Service Bulletin

Subject: **Silencers heatshield**

Product: **Brutale 1000 Serie Oro - RR - Rush**
from VIN ... LV000011 to VIN ... MV000472 (MV000451 excluded)
from VIN ... MV000483 to VIN ... MV000504
from VIN ... MV000506 to VIN ... MV000509

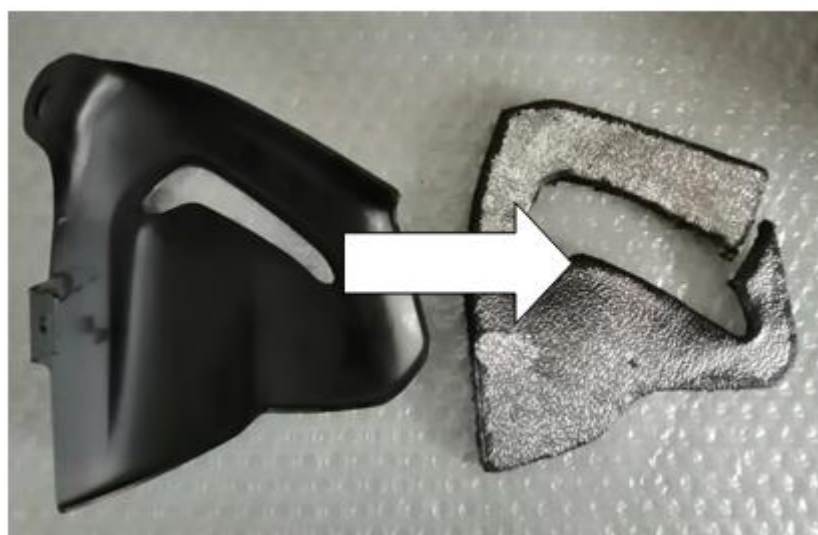
Following continuous monitoring of the quality of our product, it was found that for the Brutale 1000 Serie Oro - RR - Rush motorcycle you purchased it is necessary to replace the righthand shield located on the silencer and remove the left heat shield always present on the silencers.

- Remove the external fixing screw of the heatshield (5 mm Allen key + Torx 30):

- To reassemble the components, proceed in the reverse order of the disassembly sequence.
- Tightening torques:
 - o internal fixing screw of the heat shield: 10 Nm
 - o external fixing screw of the heat shield: 10 Nm
 - o left passenger footrest screws: 24/28 Nm

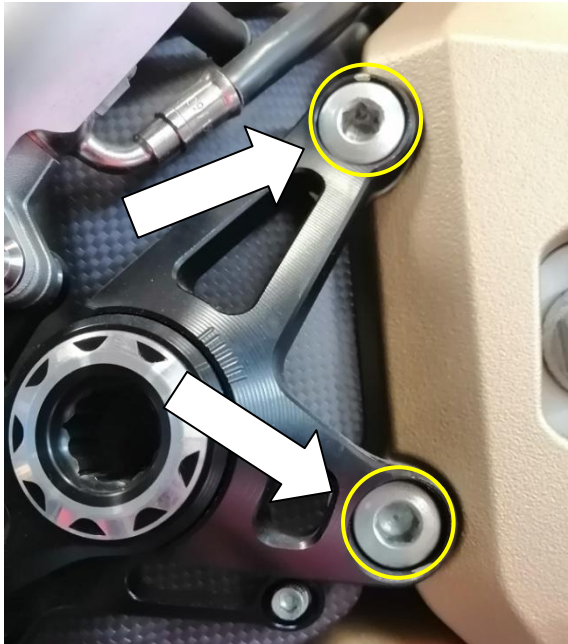
- Remove the internal insulation layer:

NOTE: the left side internal insulation layer must NOT be re-applied.

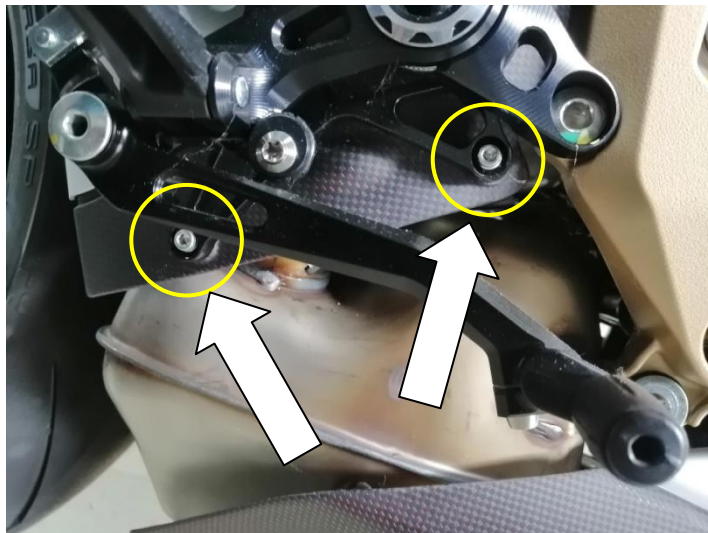
- Remove the rider footrest (8 mm Allen key) and protect it adequately to avoid damaging other components during operations:

- Glue the new inner insulating layers supplied cod. 8000C9591 e 8000C9592:

NOTE: the new heat shields cod. 8000C9591 and 8000C9592 are applicable on all models B4 1000 RR, B4 1000 Serie Oro and Rush.

- To reassemble the components, proceed in the reverse order of the disassembly sequence.
- Tightening torques:
 - o external fixing screw of the heat shield: 10 Nm
 - o lower fixing screws of the heat shield: 10 Nm
 - o rider footrest screws: 24/28 Nm
 - o passenger footrest screws: 24/28 Nm
